All D6412 and D4412 control panels with EPROM revision 1.08 and lower.

1.0 Issue

Figure 1: EPROM Location and Revision

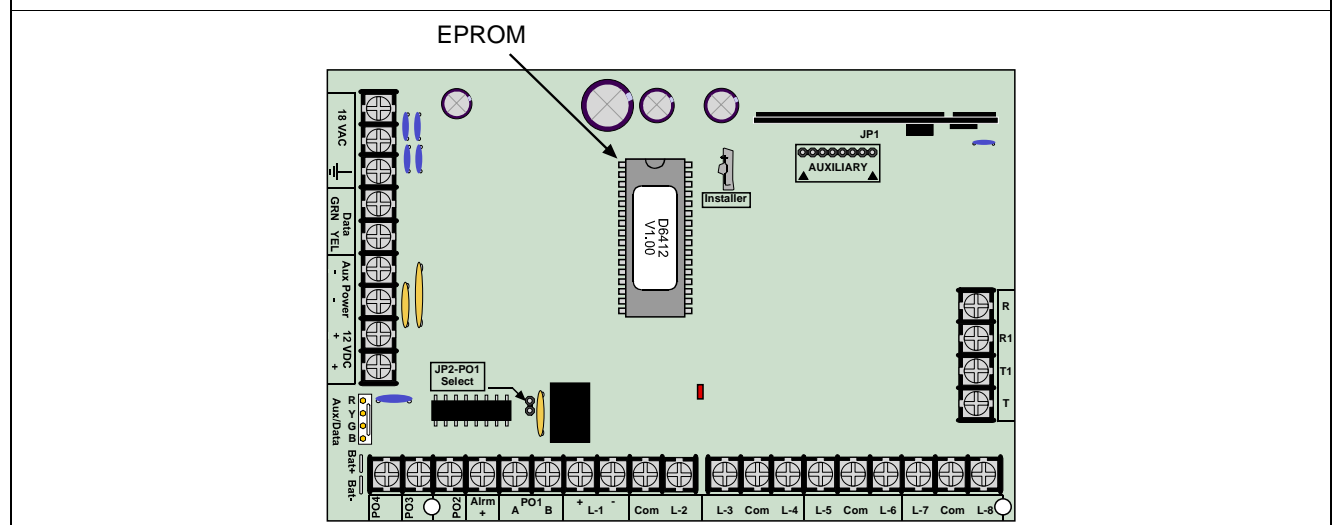
- have a D6412 or D4412 Control Panel with EPROM revision 1.08 (*Figure 1*) or lower,
- use Remote Programming Software (RPS), and
- use Enhanced Direct connect, where the PC is connected to the DX4010i Serial Interface Module through a serial cable,

RPS **might** timeout when transferring changes to the control panel.

For the control panels listed above, clicking the **Send** button **might** cause the control panel to reset and RPS to time out. A dialog box indicates that RPS timed out. If this dialog box appears, proceed to *Section 2 Resolution* on page 2.

This issue does not exist for D6412 and D4412 Control Panels with EPROM revisions 1.10 and higher.

There is an upgrade available. To upgrade your EPROM to revision 1.10, contact Customer Service at (888) 289-0096. Give Customer Service the current ROM revision located on the EPROM (*Figure 1*).

Request the appropriate EPROM Upgrade kit:

- D6412 request P/N: D6499-0110
- D4412 request P/N: D4499-0110
